Flight Procedures Cover Page	Task Action: FLIGHT CHECK	Task Type: IAP	Estimated Chart Date: 03/19/2026	APWS Task ID: E9E4186F960349D68C76122E4042A6ED	APWS Project ID: 641E96F3A9D54F2A9CB8FCE670EA4BAB
Procedure: RNAV (GPS) RWY 2 AMDT 3	Enroute: NO	Specialist: Miller, Ralph	Agreement Number:		
Airport ID: 1G3	Airport City: KENT		State: OH		
Facility ID:	Facility Type:	Flight Inspection Remark Type: New FC Slot

01/20/26: THIS IS AN UPDATED COPY OF THE FORM DEVELOPED ON 10/3/25.

RNAV (GPS) RWY 1 KENT STATE UNIVERSITY (1G3)

OLD

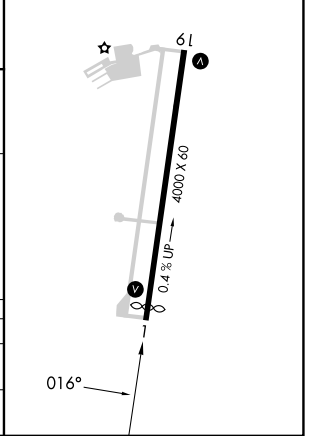
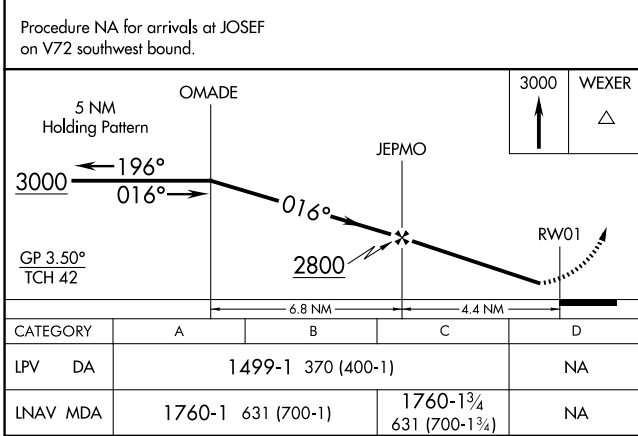
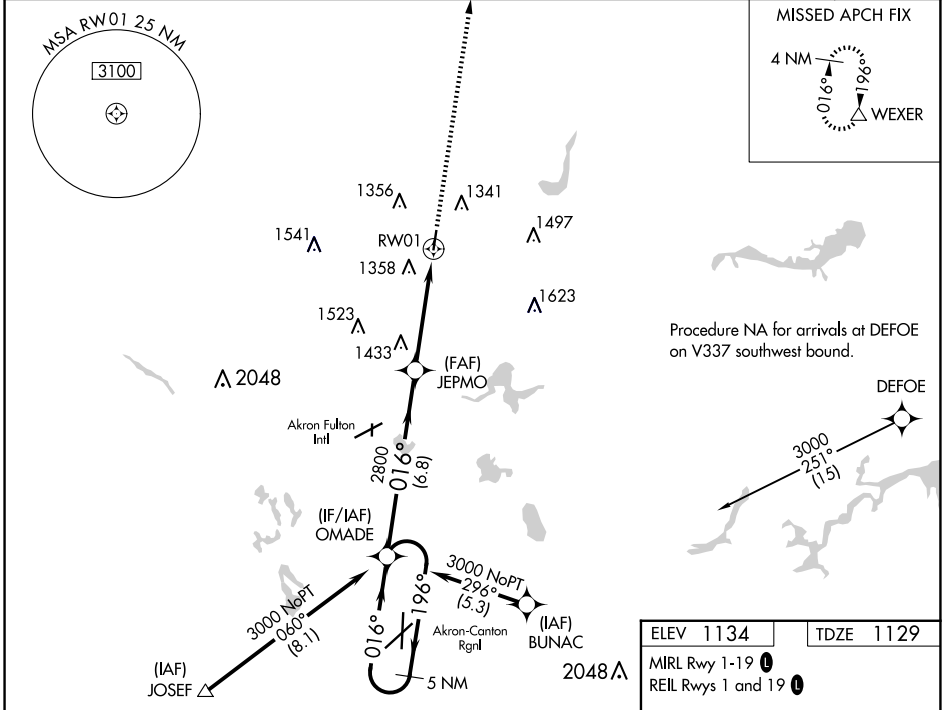
Runway Renumbering project.
feeder removed. IAFs relocated per ATC request for standard t intersection at IF. IF relocated per ATC request for 6 NM Intermediate leg. VDA updated from 3.50 to 3.68 for VGS penetration mitigation.
CRC Remainder Update from FROM FFD42DD4 TO 2F9A1AA9.
Contact Rake McGraw 405-954-8711

1. PROFILE: LINE 6: UPDATED FROM GP ALT AT PFAF: JEPMO TO GP ALT AT PFAF: JEPMO 2800 - IAW 8260.19K 8-6-7F.
2. NOTES: CHART NOTE CHANGED FROM: "WHEN LOCAL ALTIMETER SETTING NOT RECEIVED, USE AKR ALTIMETER SETTING AND INCREASE LPV DA TO 1529 AND ALL VISIBILITIES 1/8 SM, INCREASE ALL MDAS 40 FT AND INCREASE LNAV CAT C VISIBILITY 1/8 SM" TO "WHEN LOCAL ALTIMETER SETTING NOT RECEIVED, USE AKR ALTIMETER SETTING AND INCREASE LPV DA TO 1529 FEET AND ALL VISIBILITIES 1/8 SM, INCREASE ALL MDAS 40 FEET AND INCREASE LNAV CAT C VISIBILITY 1/8 SM" - IAW 8260.19K 8-6-12 N(1)(A)1.
3. ADDITIONAL FLIGHT DATA: NOTE UPDATED FROM CHART: KCAK IN PLANVIEW TO CHART: CAK IN PLANVIEW - IAW 8260.19K 8-6-2A.
4. ADDITIONAL FLIGHT DATA: NOTE UPDATED FROM CHART: KAKR IN PLANVIEW TO CHART: AKR IN PLANVIEW - IAW 8260.19K 8-6-2A.
